GATEWAY NATIONAL RECREATION AREA SANDY HOOK, NJ

HISTORIC WATER PLANT BUILDING 341
PMIS NO. 152823A

LIMITED STRUCTURAL INVESTIGATION & REPORT

PROJECT: PMIS 152823A Limited Structural Investigation & Report, Sandy Hook Water Plant Building 341

Figure 3: Diagram of the Parapet wall and the southeast corner of Building A showing typical large holes in roof membrane near scupper.

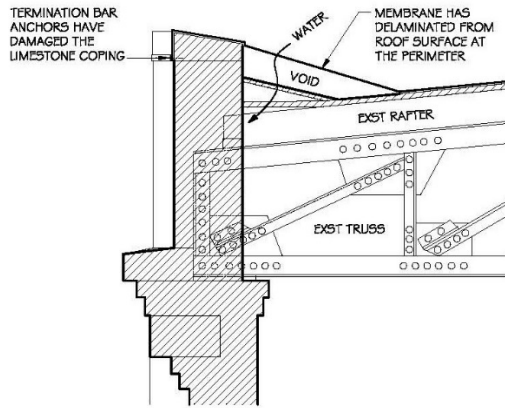
15.	Page 6	Figure 3: Change "structural" to "structurally".	Changed to "structurally"
16.	Page 6	Clarify west, east, north and south (typical throughout document); for example, there can only be two stepped 1910 walls – yet 3 are noted. A key plan with north arrow would be helpful. The written orientations and location descriptions such as "base of purlins" are insufficiently clear (confusing to most); thorough photos with delineations would be helpful throughout document. Dimensions (i.e. square & linear feet) delineated on photos would be helpful throughout document. Identify portions of building (i.e. areas A, B & C from SOW, or similarly).	Key Plan has been added.
